A Rosenthal's Sketch & Explana-
tion of Surveys on the upper
Guadalupe.

Dated July 1873 -

Comfort August 2^d 1873

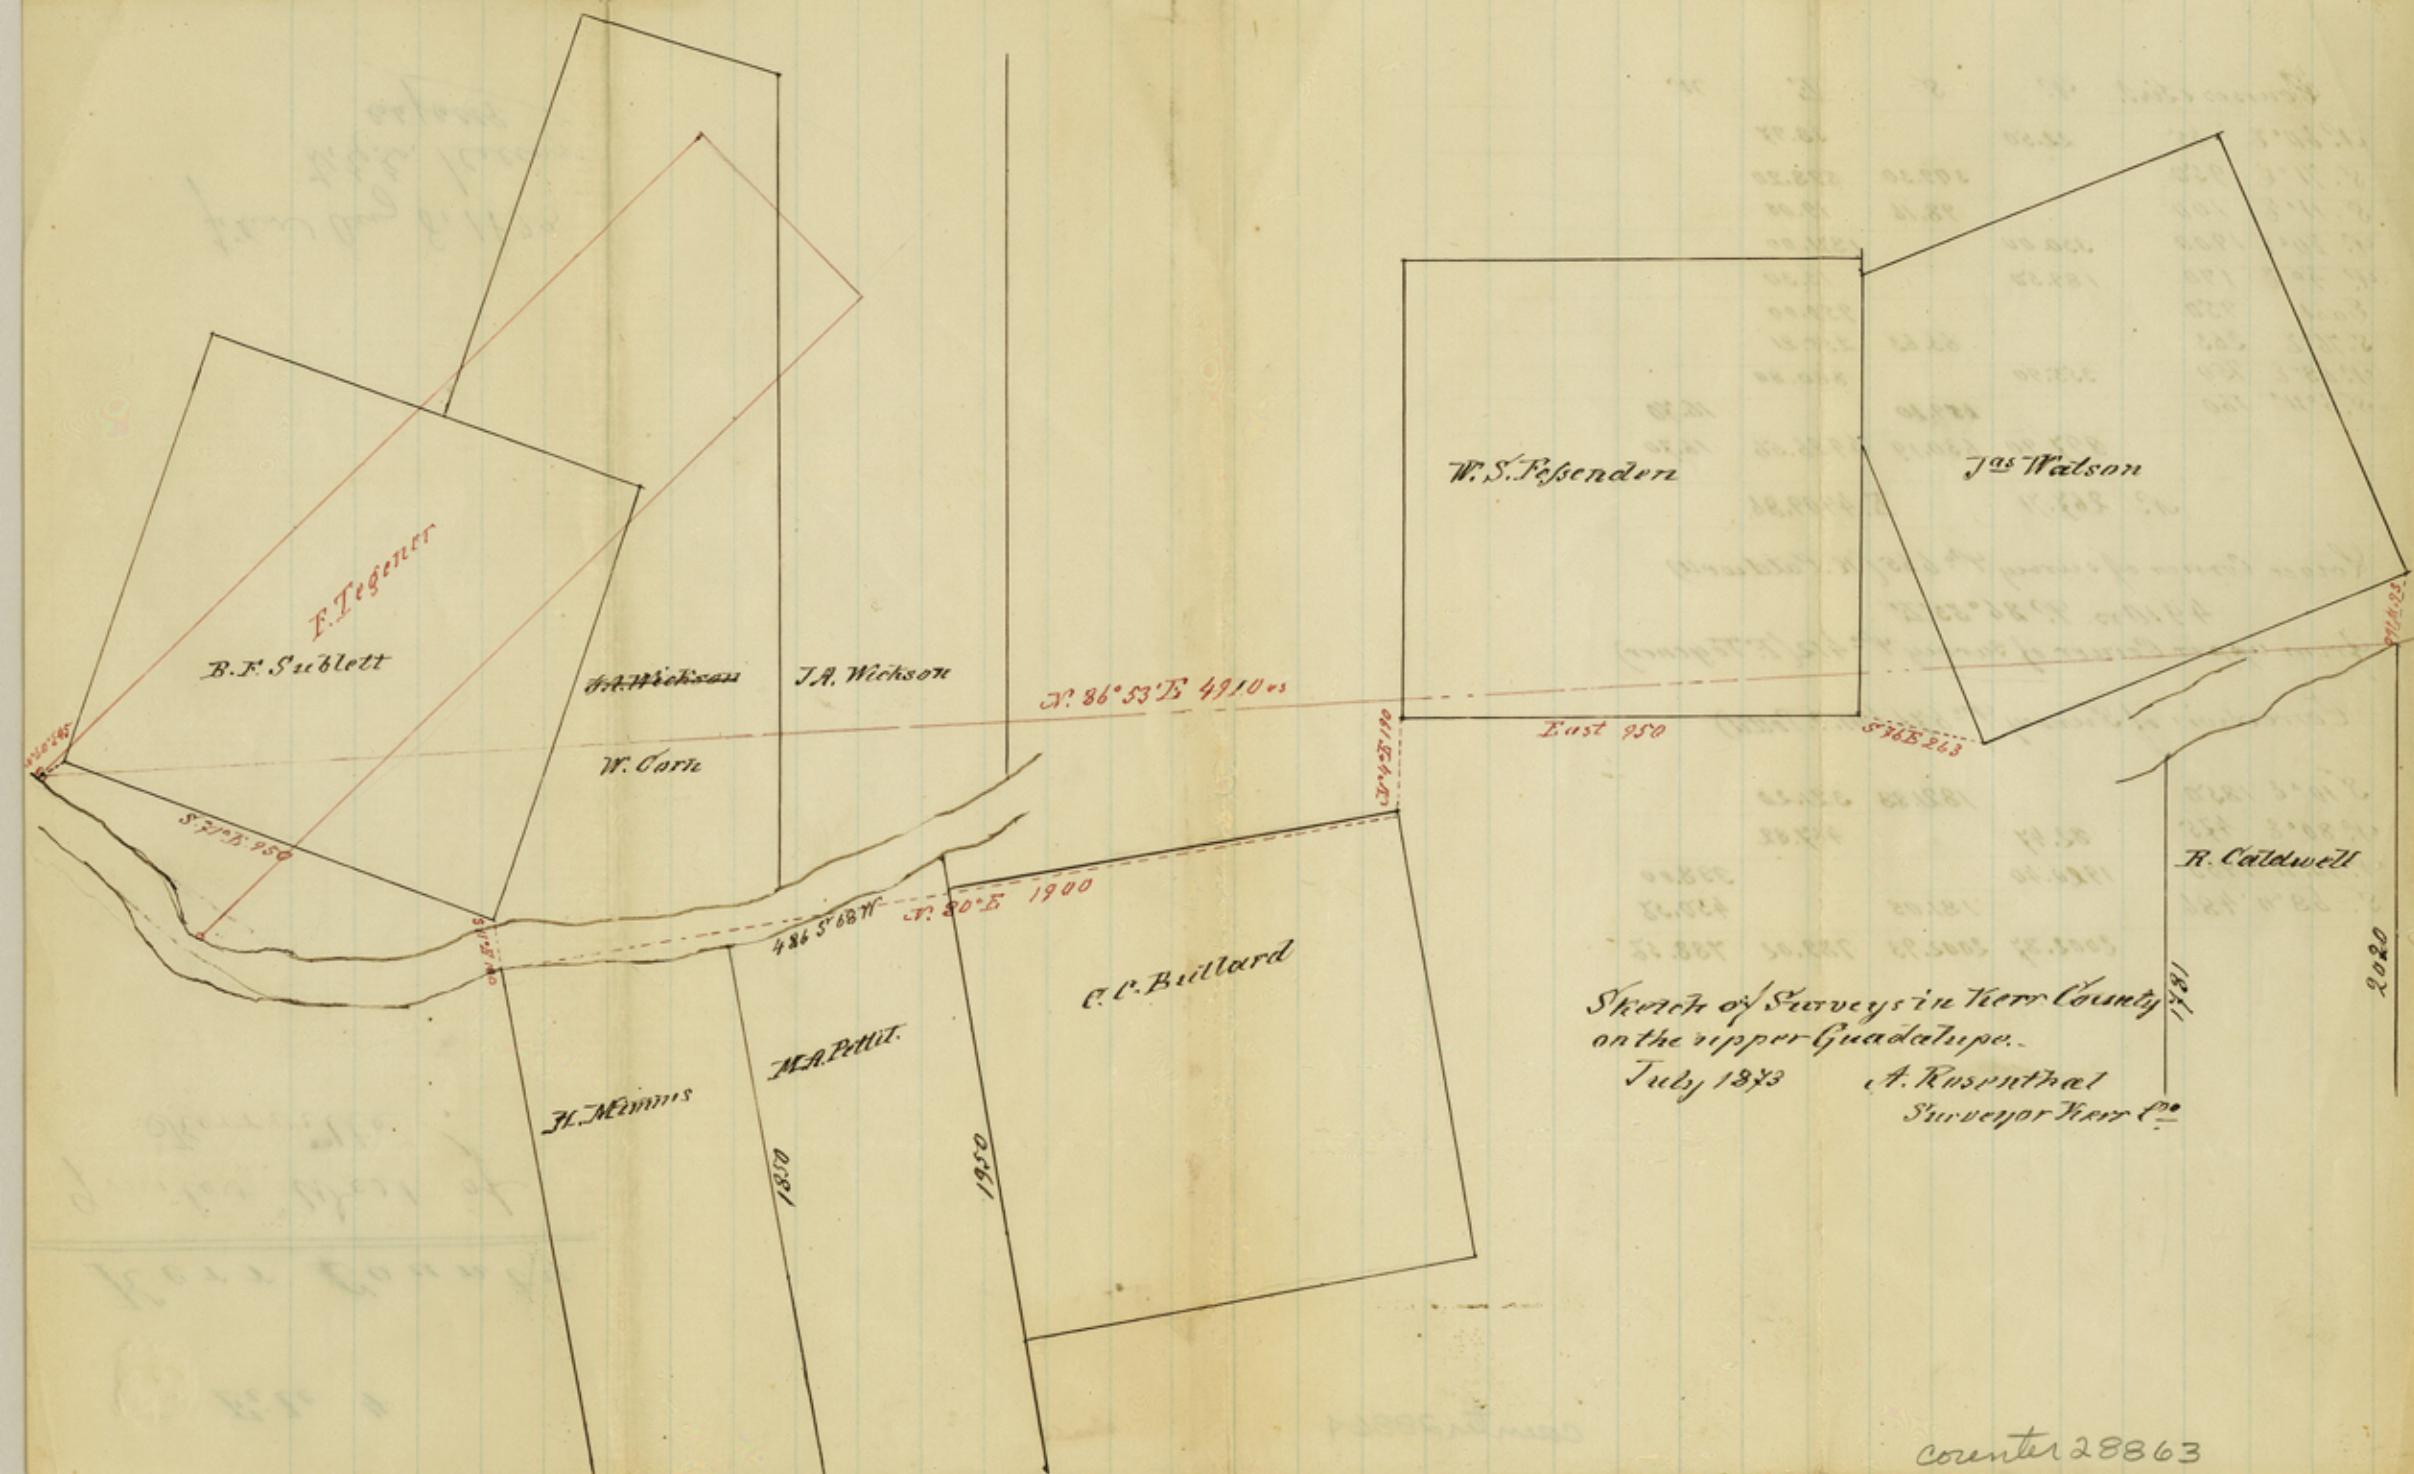
I herewith respectfully transmit
to your office several corrections of surveys made
by me in Kerr County. Enclosed you will find a sketch
and calculation, showing the connection of Survey

#^o 665 (R. L. Aldrook) with the upper corner of Survey
#^o 664 (R. L. Aldrook) as found by the plotting of the
different surveys between them. I believe, the rule is
that later surveys correct former connection lines, so if
there is a discrepancy between the connection given
in the field notes of the R. L. Aldrook survey and the
one now given, I presume, the proper way is to take
the latter. I send my calculation, because I could not
make out, what the connection as stated by your letter
July 23, should be $9^{\circ} 88' E.$. In regard to the error in
the calculation of survey #^o 676 (W. A. Peeler) I respectfully
ask, to change the fieldnotes of the same, according to
the annexed calculation. At the time of sending these
fieldnotes to your office, I requested Mr. Dr. Begener
to make a statement, that his claim was given
up, and I believe about this time he will have

Correction of Survey #^o 676 (M. A. Pettit)

Lower corner of survey #^o 665 (R. Caldwell)

4910 m. N. $86^{\circ} 53' E$

from upper corner of survey #^o 412 (E. Tegener)
